**CHABOT-LAS POSITAS
COMMUNITY COLLEGE DISTRICT
PURCHASING DEPARTMENT**

**Addendum No. 1
INVITATION TO BID.: B21/22-01
DISTRICT WIDE SECURITY MANAGEMENT
SYSTEMS REFRESH PROJECT**

Project:
 CLPCCD
 SECURITY MANAGEMENT
 SYSTEM REFRESH PROJECT

Job No: 19.749
 Scale: 3/32" = 1'
 Date: 10/2/19
 Sheet No: C-B0200.1

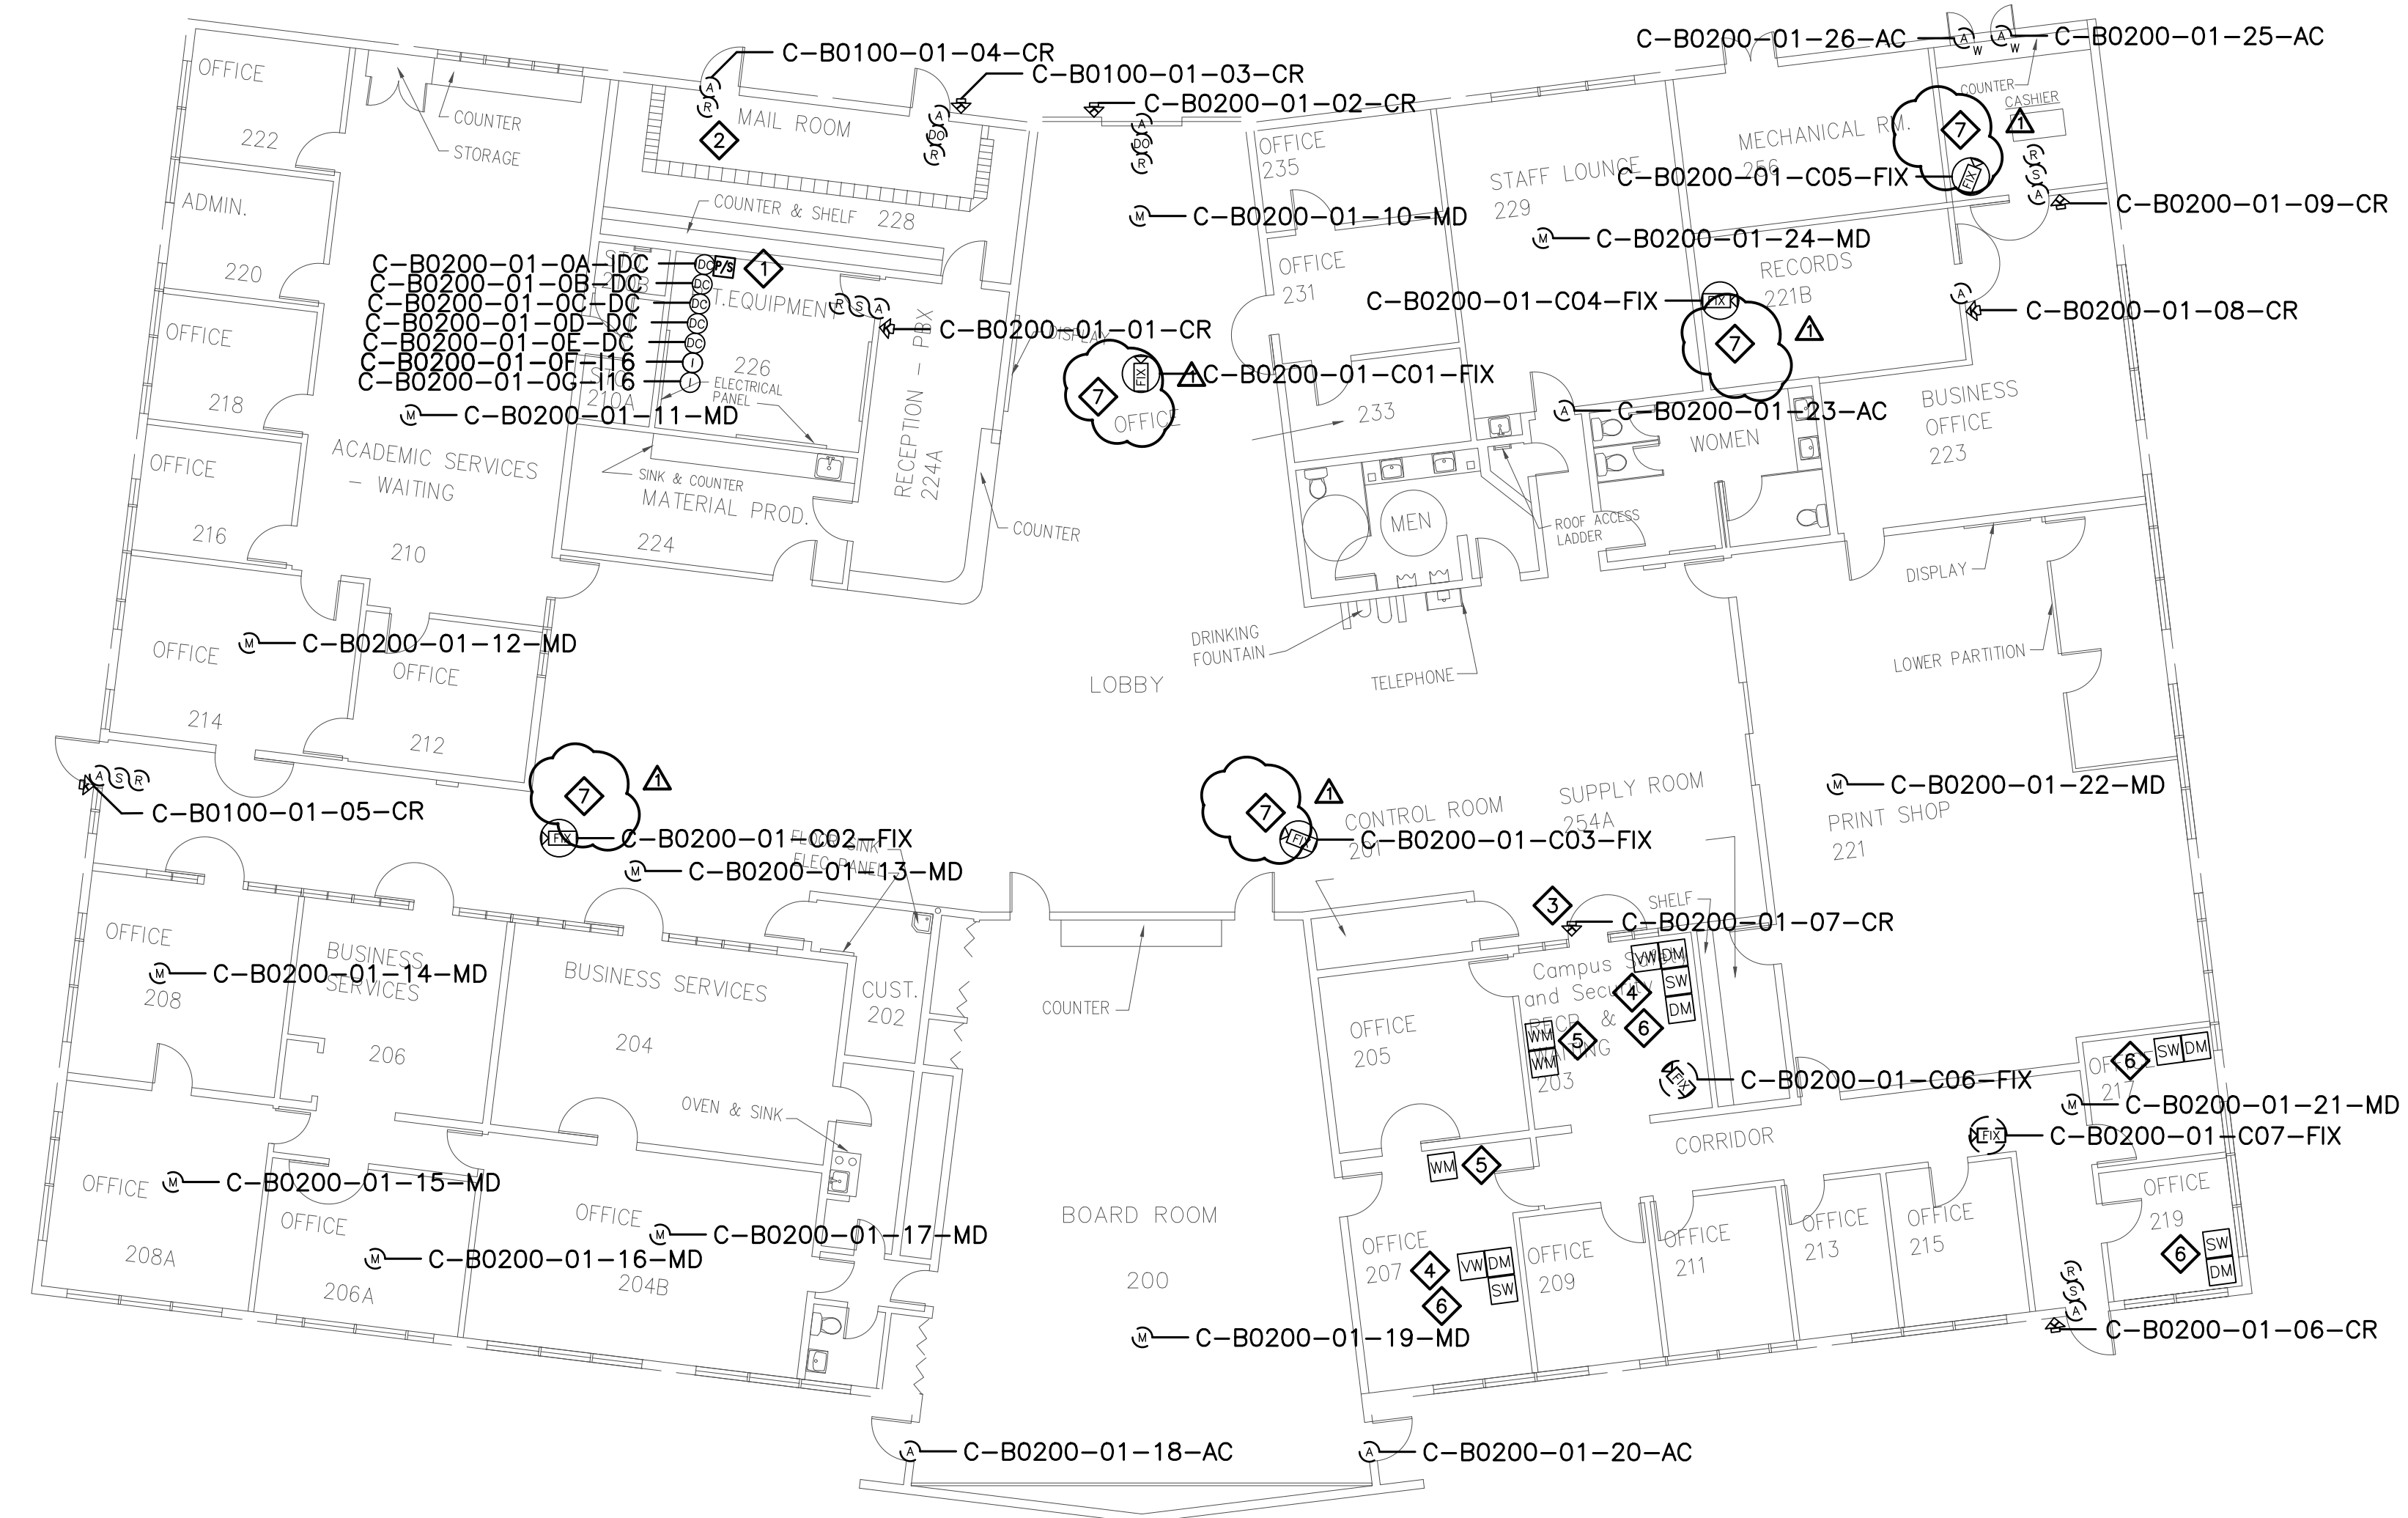
Question 11: Drawing C-B0200.1 Sheet Note #4 states "INSTALL NEW LPR/VSS WORKSTATION PC AND

MONITOR AT EACH DESK LOCATION..." and has 2 designated locations on the drawings at desks. However, there are 5 designators at fixed camera locations, not desks. Please clarify; does this note # apply to the 5 camera locations or is there some other requirement for these locations?

Response: The sheet note 4 symbols that are next to cameras on this sheet are incorrect. A sheet revision will be issued under the addendum that adds Sheet Note 7 and updates the sheet note symbol associated with these cameras from 4 to 7. Sheet note 7 will state, "REMOVE (E) ANALOG CAMERA CABLING FORM (E) RACEWAY AND INSTALL (N) ETHERNET CABLING, PER DIVISION, IN (E) RACEWAY TO IDF 226. COORDINATE TERMINATION TO (E) NETWORK SWITCH PORT AND NETWORK CONFIGURATION WITH CAMPUS ITS REPRESENTATIVE."

- 7 REMOVE (E) ANALOG CAMERA CABLEING FORM (E) RACEWAY AND INSTALL (N) ETHERNET CABLEING, PER DIVISION, IN (E) RACEWAY TO (E) NETWORK SWITCH PORT AND NETWORK CONFIGURATION WITH CAMPUS ITS REPRESENTATIVE.

Job No: 19.749
 Scale: 3/32"=1'
 Date: 10/2/19
 Sheet No:
 C-B3900.1

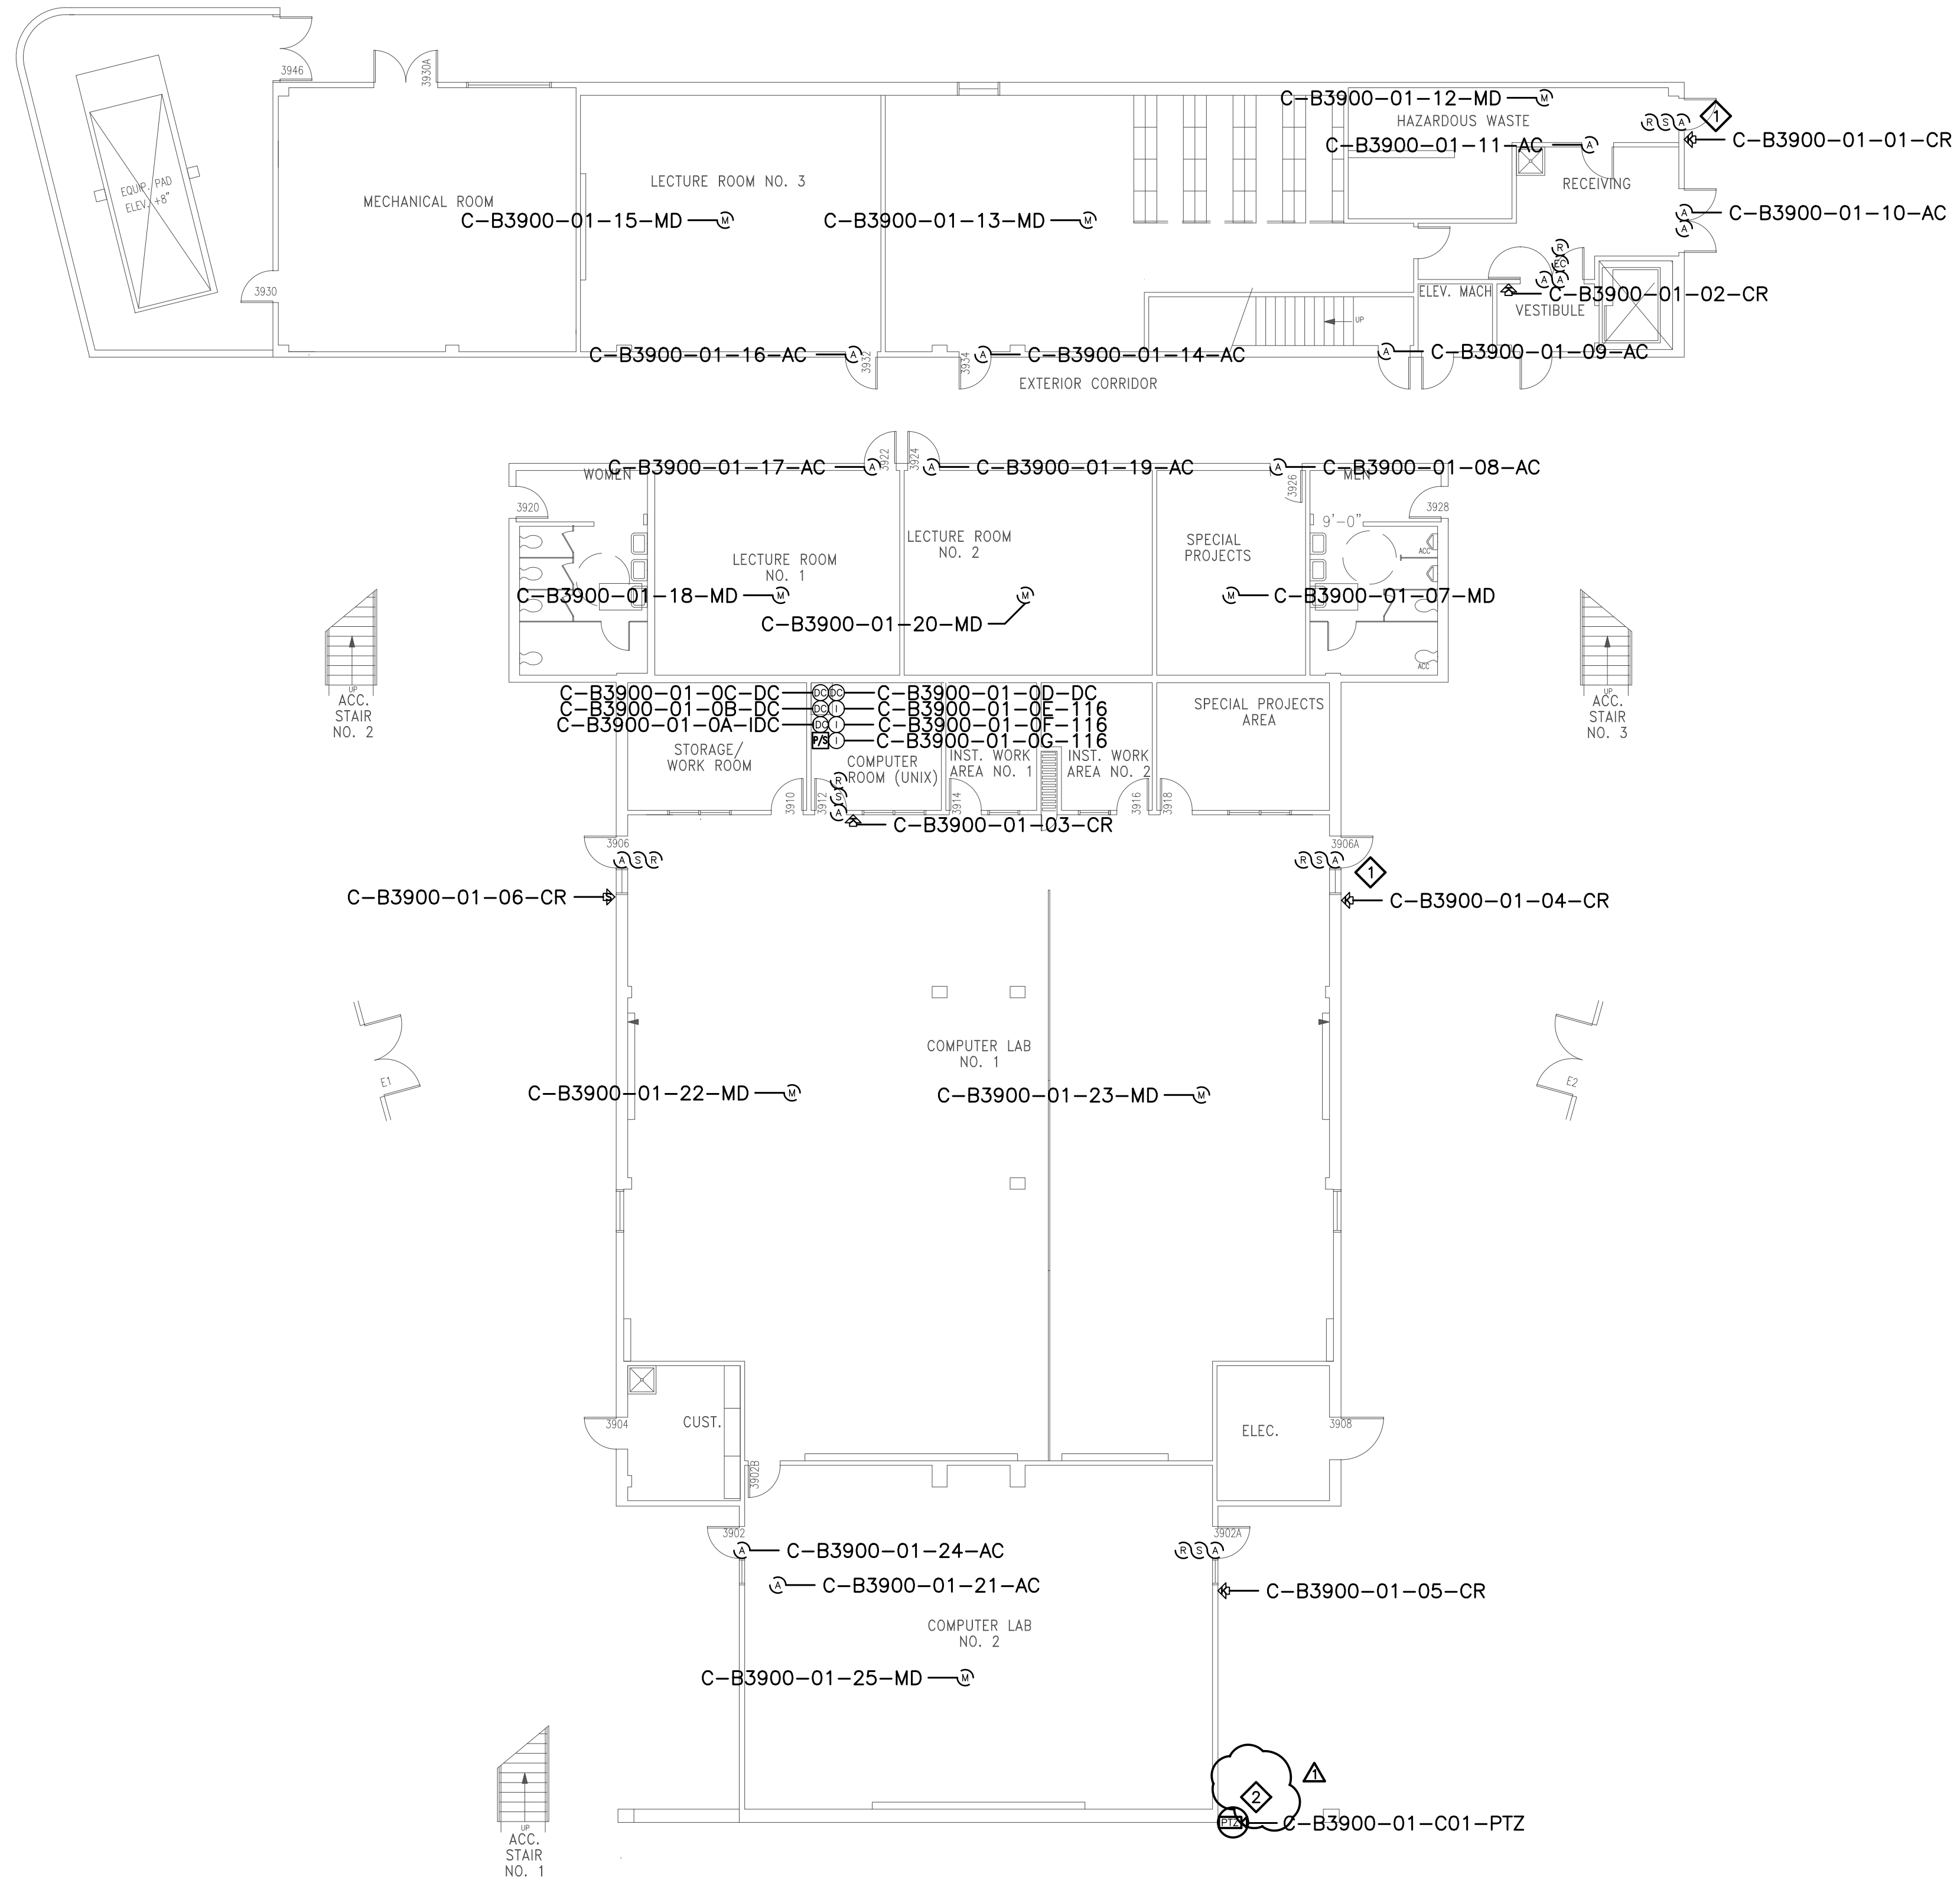
Question 10: Drawing C-B3900.1 Sheet Note #2 states "REMOVE (E) ANALOG CAMERA CABLING FORM

*E) RACEWAY AND INSTALL (N) ETHERNET CABLING." but there are no locations designated on the drawing. Please clarify which location(s) this note refers to.

Response: The sheet note 2 symbol is missing for the PTZ camera designated C-B3900-01-C01-PTZ. A sheet revision adding the symbol to this location will be issued under the addendum.
